AGENDA

- a. Public hearing on a Conditional Use Permit application for a Community Solar Energy Collection System, requested by Wisconsin Power & Light, an Alliant Energy Company, located at 3443 Siggelkow Road, parcel # 0710-354-8341-1.

McFarland
SUMMARY SHEET

CUSTOMER HOSTED SOLAR: MCFARLAND SCHOOL

SWPPP & EROSION SEDIMENT CONTROL PLAN

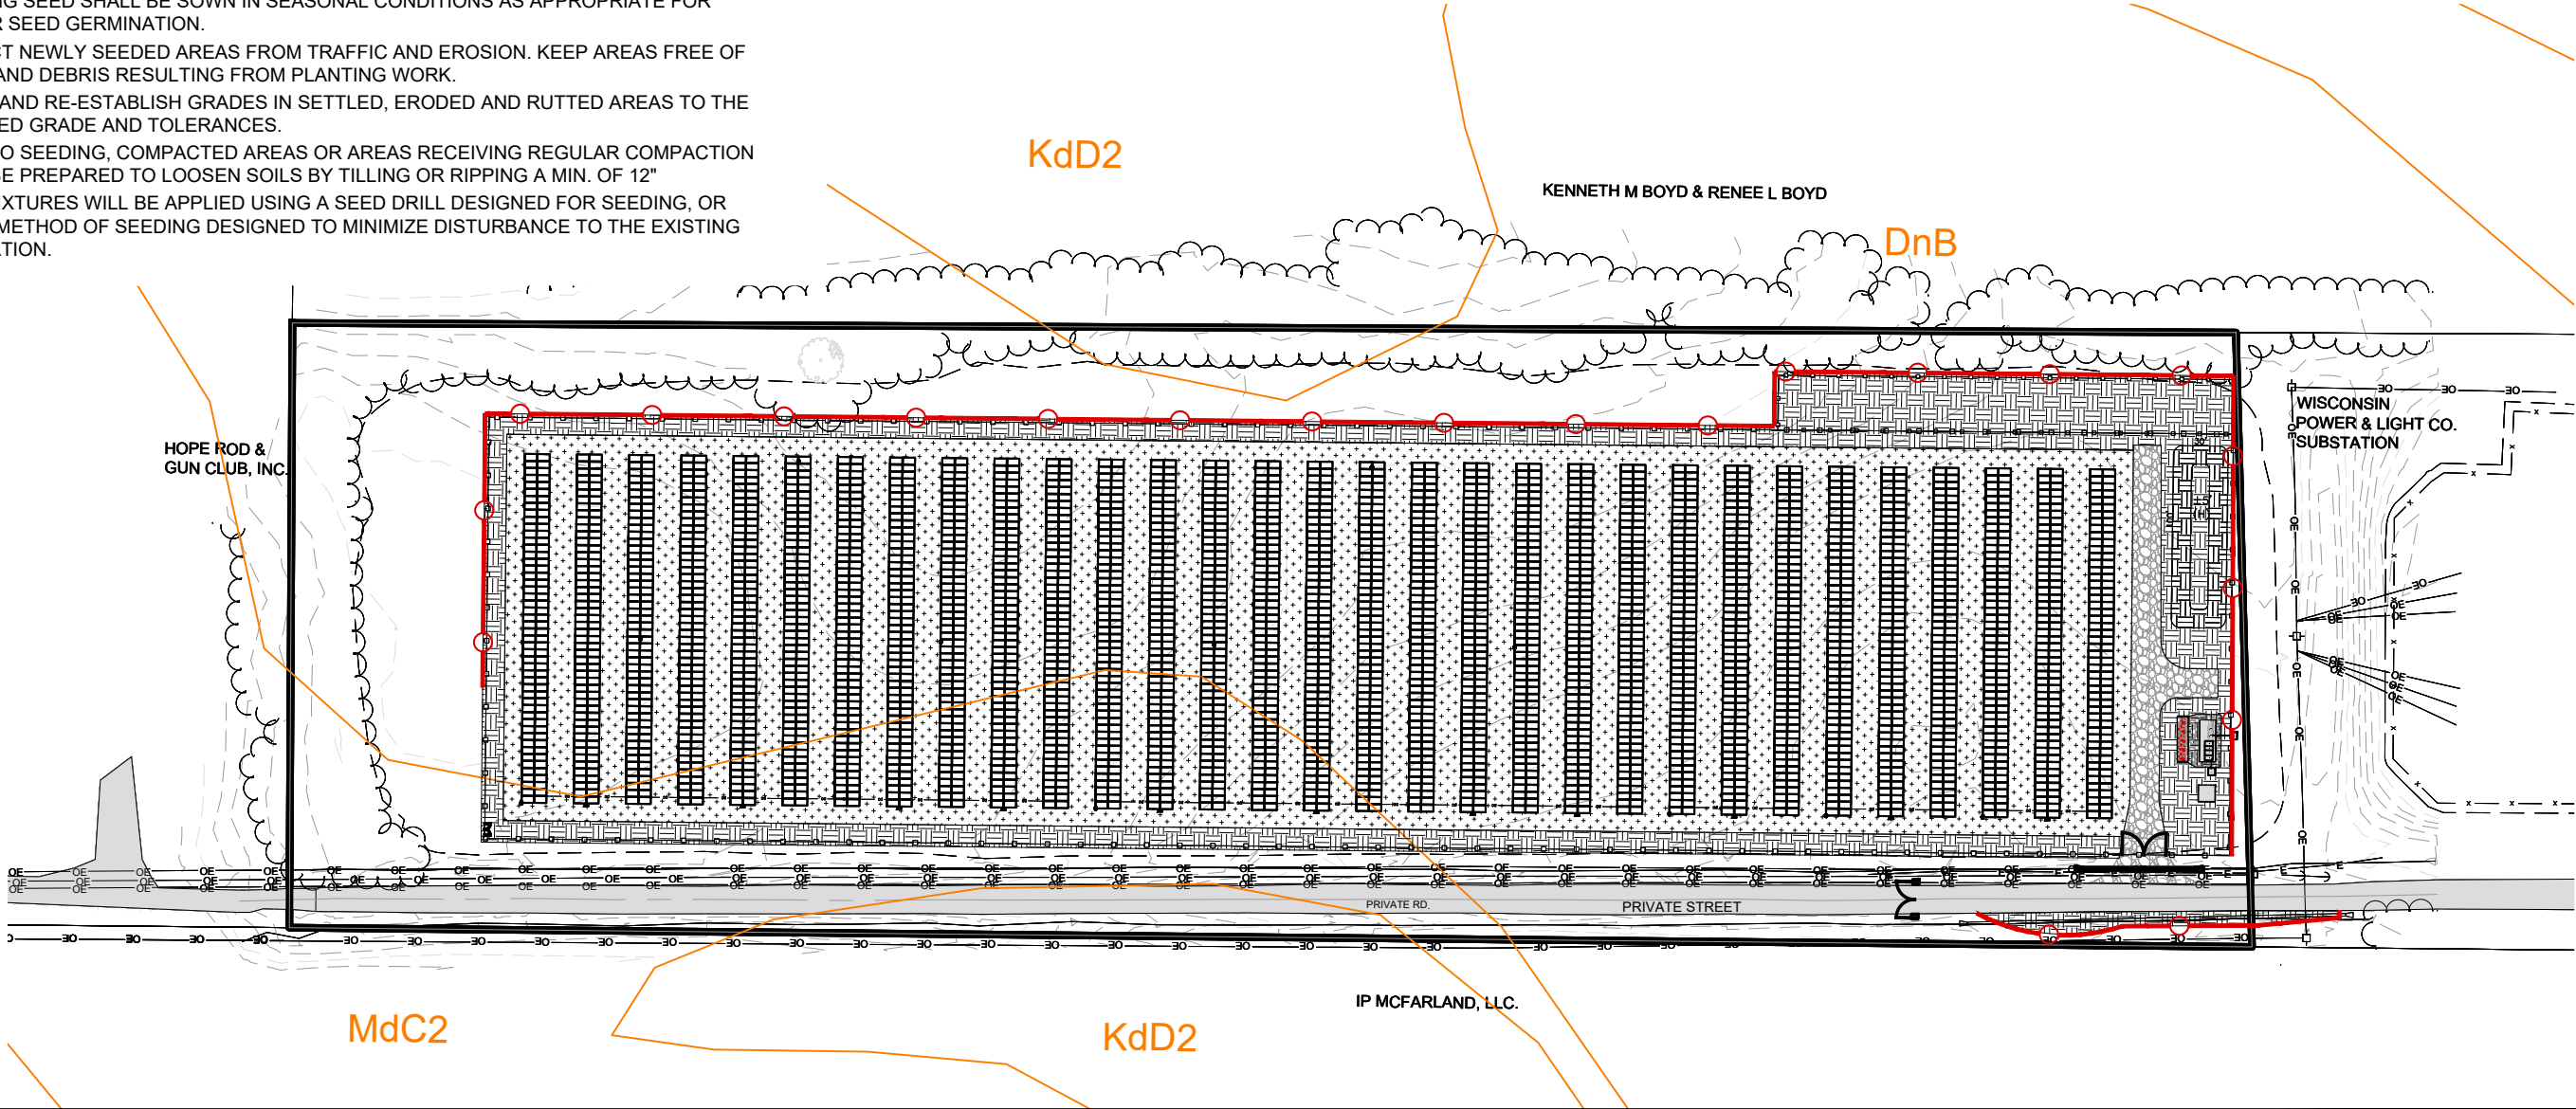
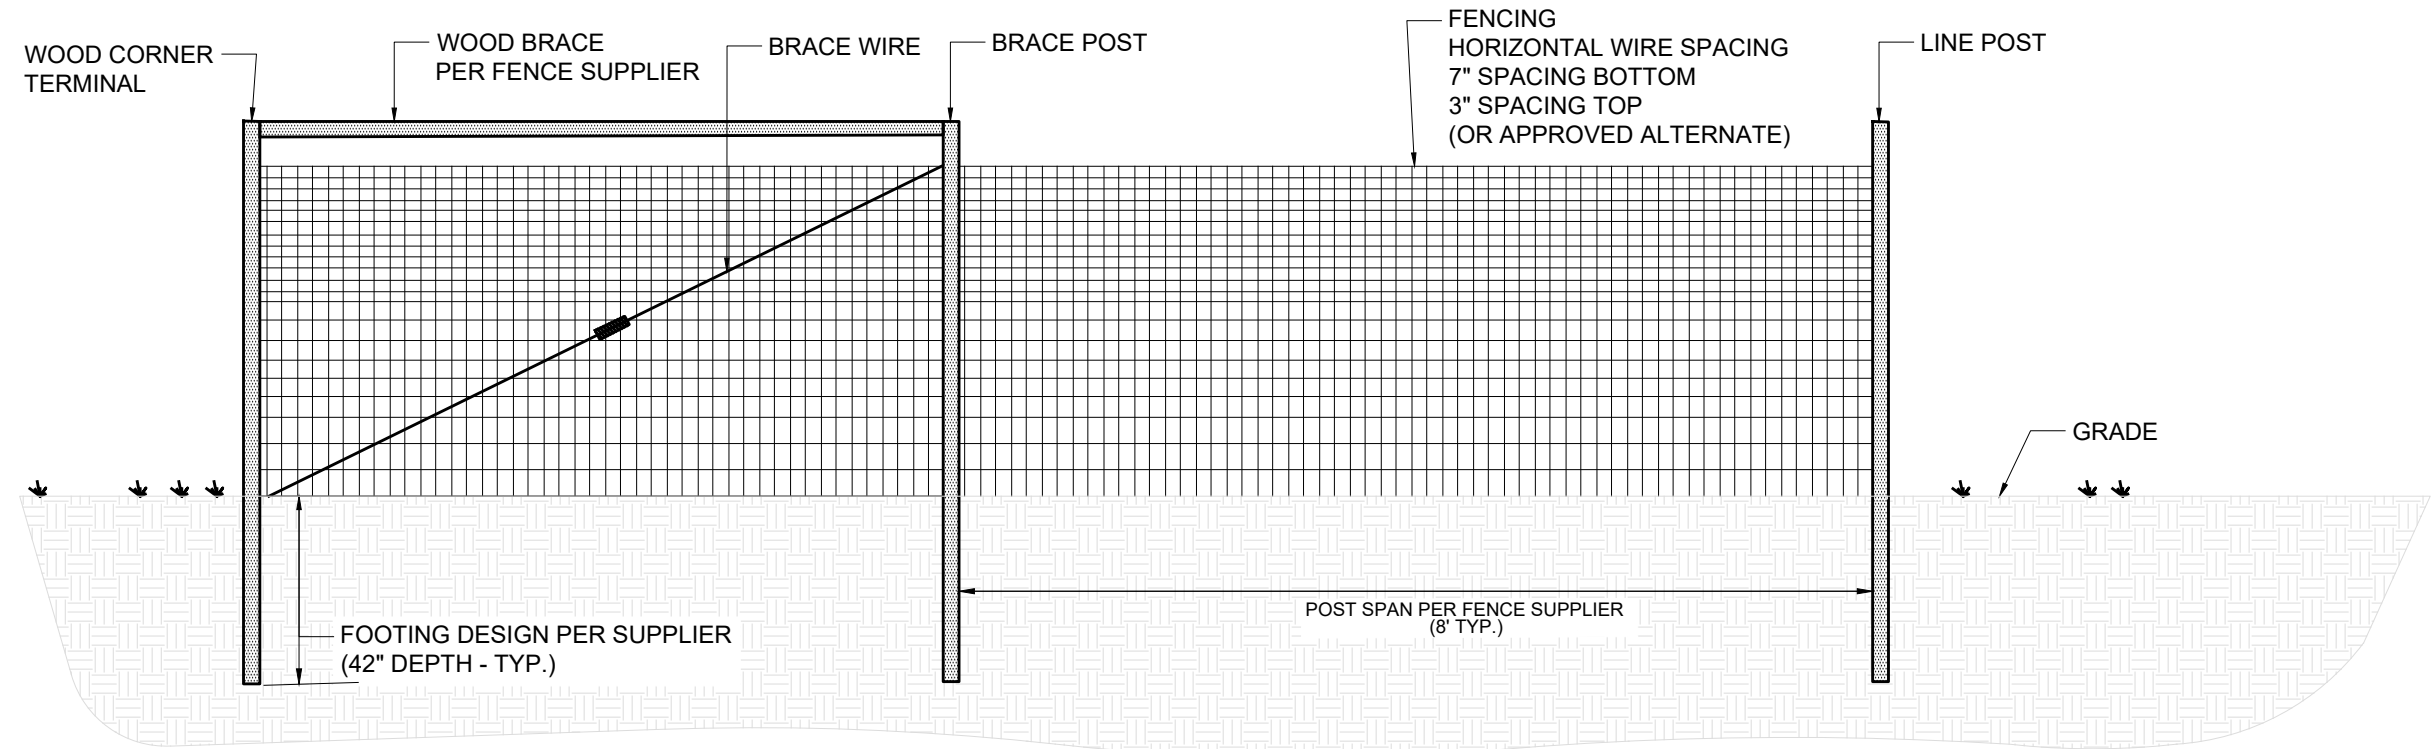
6. Stormwater Management and Erosion Control. An erosion control plan was submitted with the application. The project adds a 4,960-square-foot gravel access driveway and 300-square-feet of concrete electrical pads. Included in the packet is the Village Engineer's letter with suggested updates to the final stormwater management and erosion control plan, including:

- c. A cost estimate for the erosion control and stormwater management should be provided, along with a surety for the proposed work.
 - d. A long-term maintenance plan for the vegetation cover and the down gradient buffer area.

D-3 TYPICAL 8' TALL GAME FENCE
NOT TO SCALE

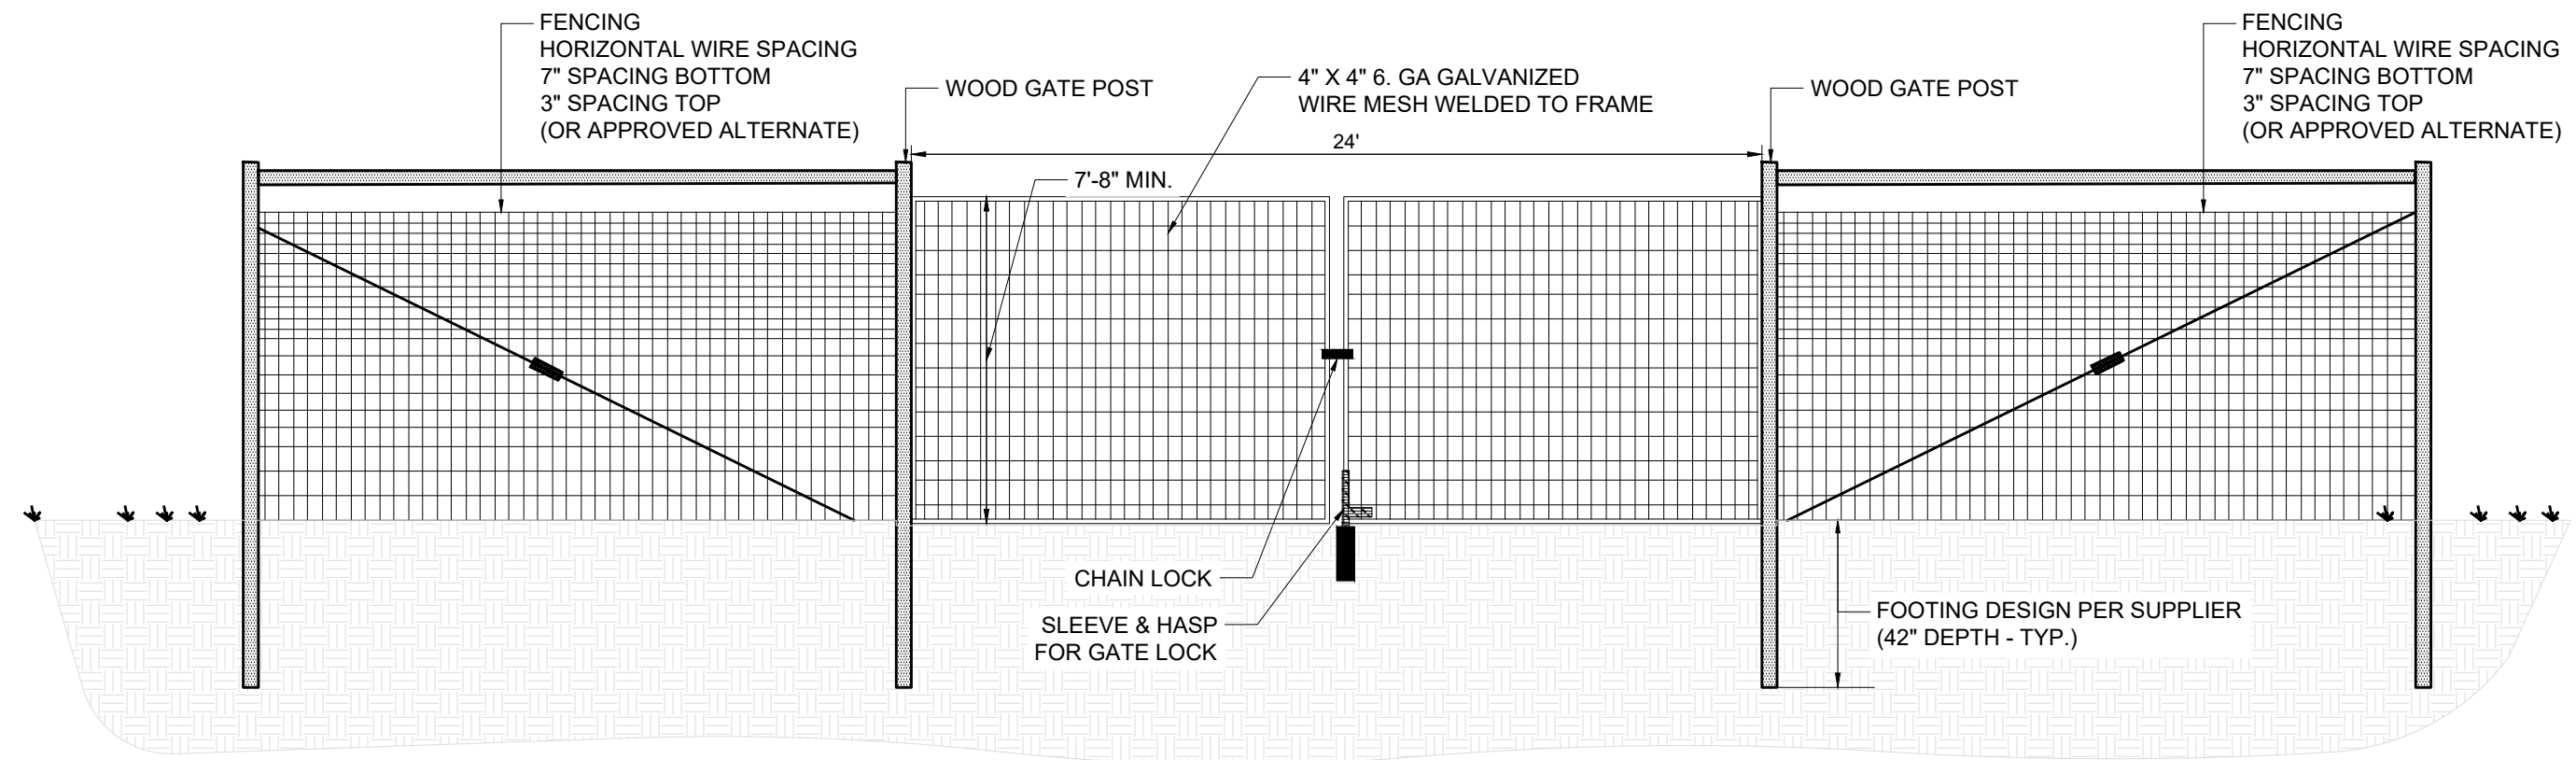
8. Fencing and Security. Fencing around the property is setback approximately 50 feet from the adjacent west, south, and east lot lines. Along the north lot line, the fence tapers from east to west, from approximately 10 feet down 1.5 feet. The height of the fence is 8 feet tall and consists of wood posts and woven wire. Refer to Sheet C600. On Sheet C602, the design of the proposed gate along the easement driveway extends 18 feet across, standing approximately 4 feet tall. The section standard requires the system equipment to be fully enclosed and secured with warning signs posted. Additionally, a Knox box should be provided at locked entrances for emergency personnel access. The Village Fire Chief's comments include recommendations for a Knox box. The submittal meets the standard for a fully enclosed fence but does not include details regarding the

- Knox box. As a condition of approval, one would be provided at the fenced entrance.
9. Decommissioning. The lease agreement details the plan for decommissioning of the site once the panels have reached the end of product life.

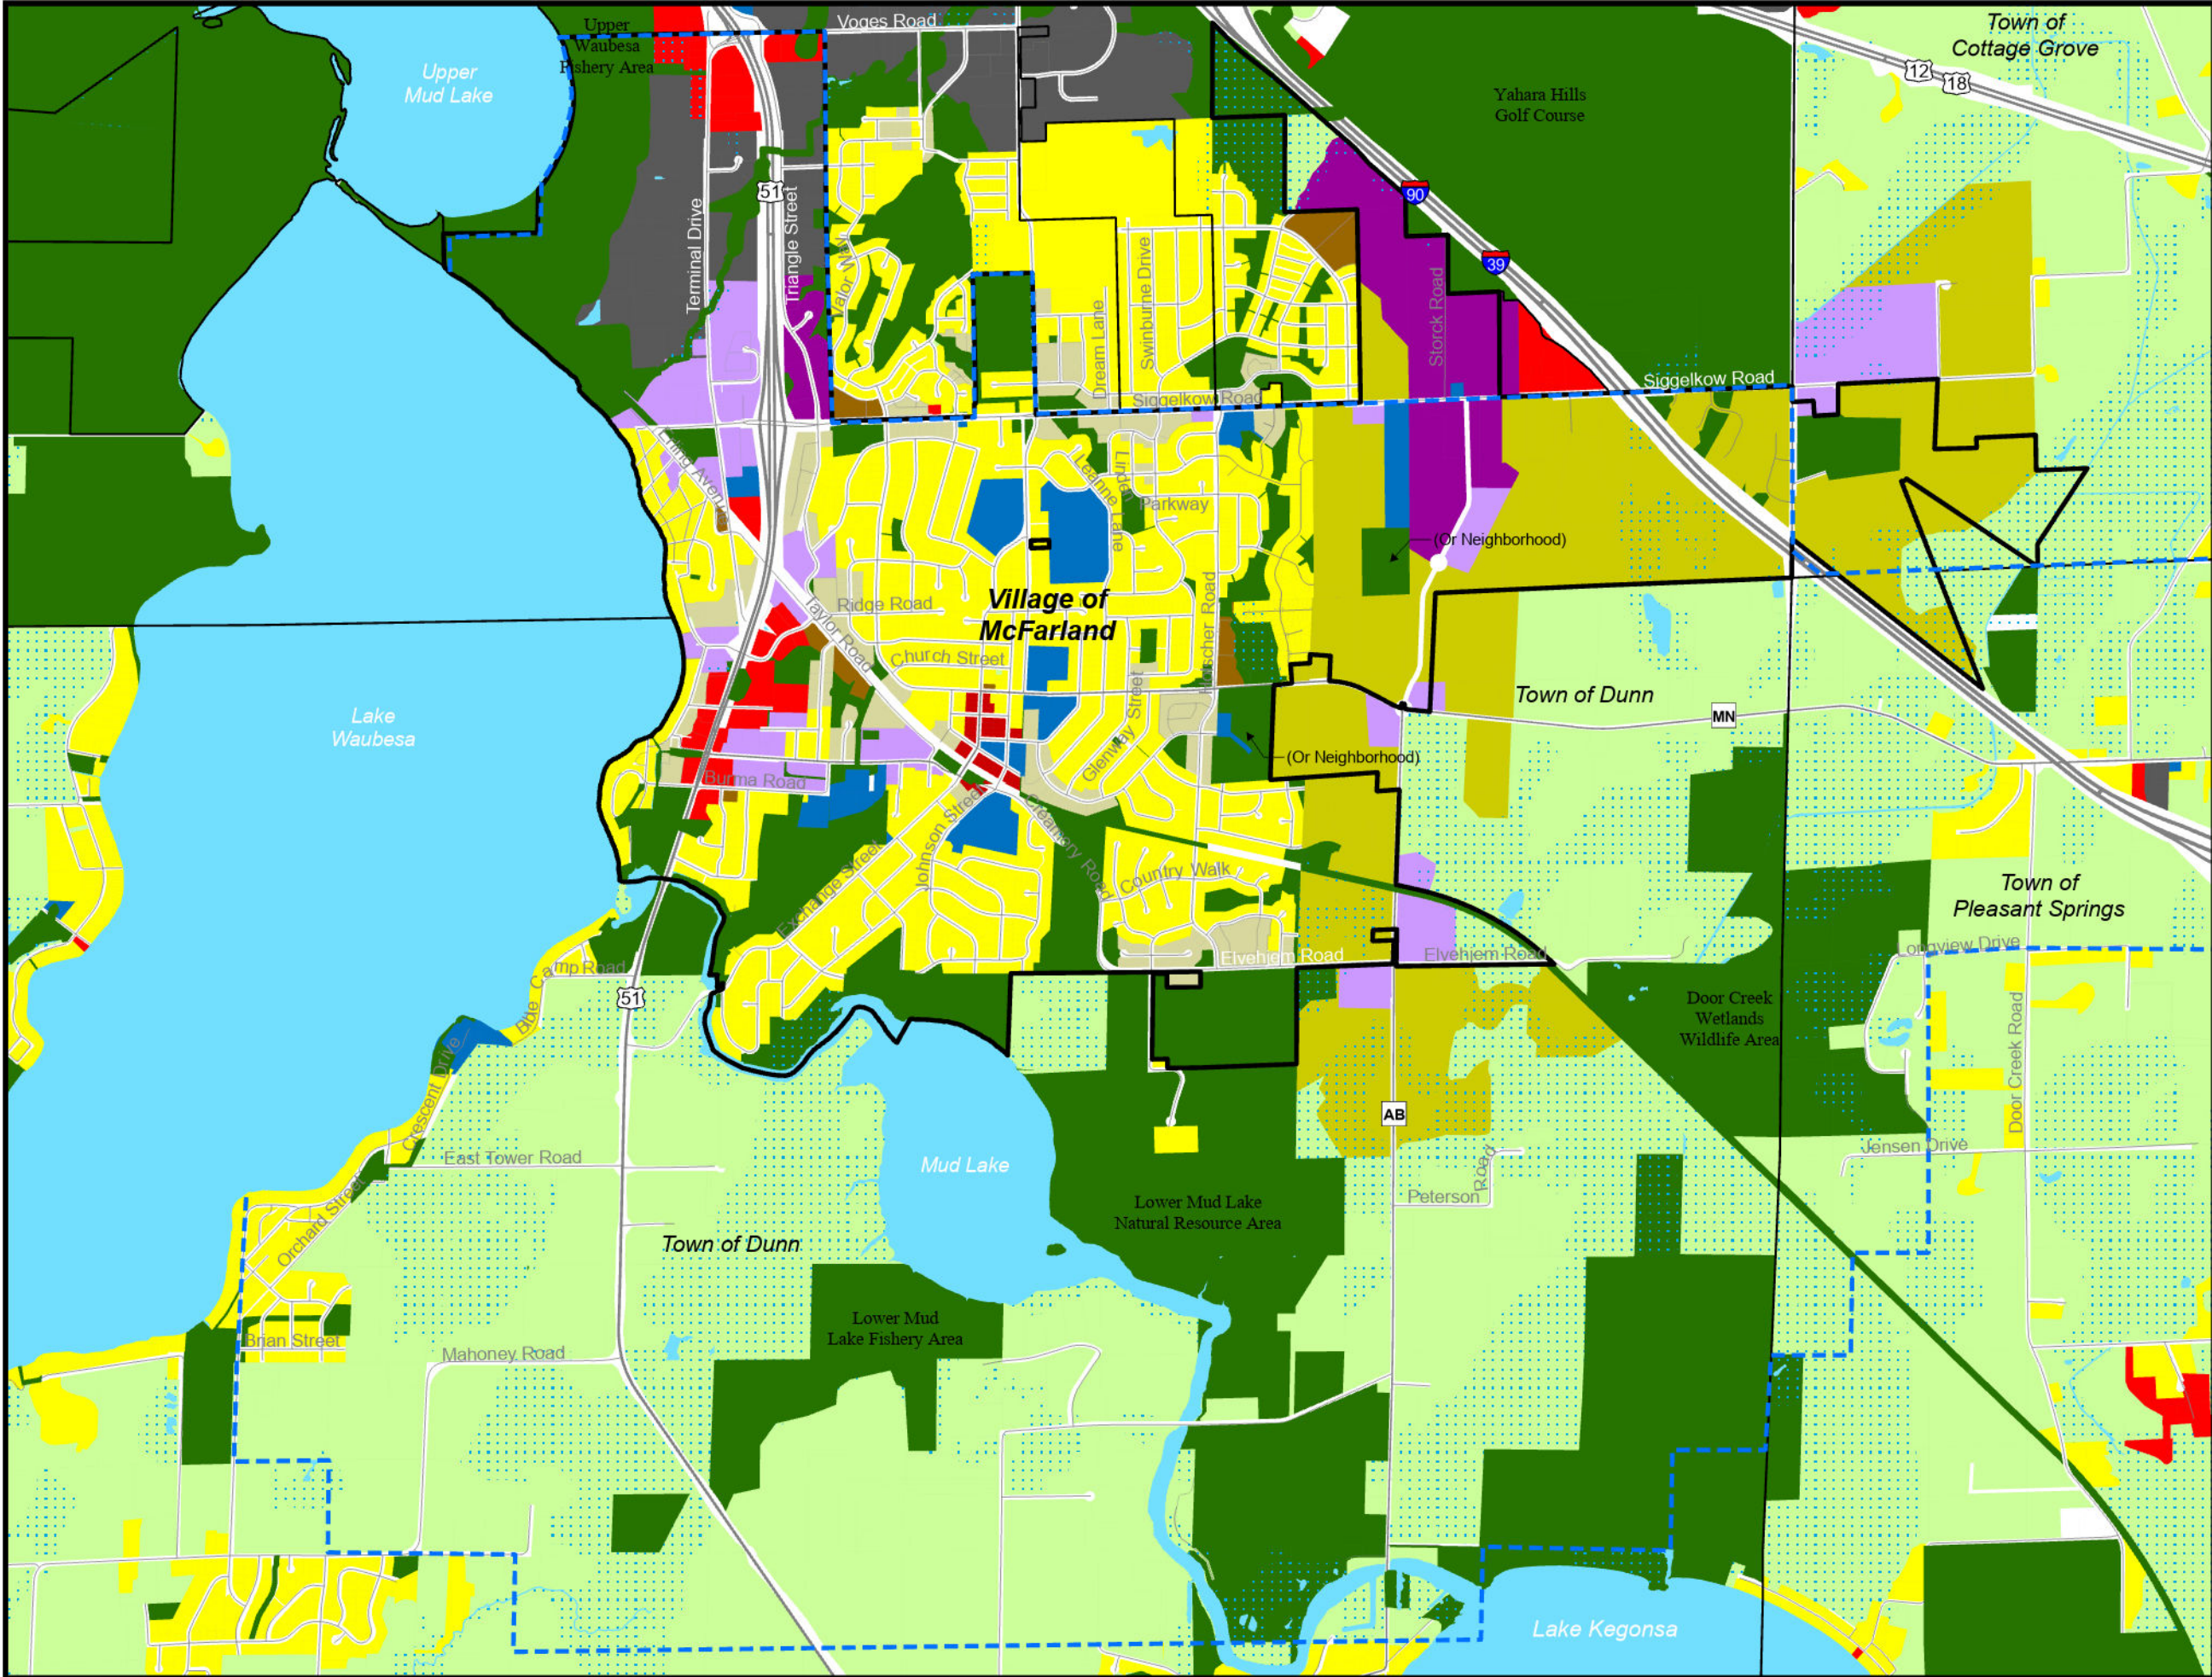
- The required turning radius for fire department access roads is 28' for turns greater than 60 degrees and 26' for turns of 60 degrees and less (Based on IFC figure D103.1. The entrances to Lot 1 and Lot 9 don't appear to meet the requirement.

IFC D105.1 Where the vertical distance between the grade plane and the highest roof surface exceeds 30 feet (9144 mm), approved aerial fire apparatus access roads shall be provided. For purposes of this section, the highest roof surface shall be determined by measurement to the eave of a pitched roof, the intersection of the roof to the exterior wall, or the top of parapet walls, whichever is greater.
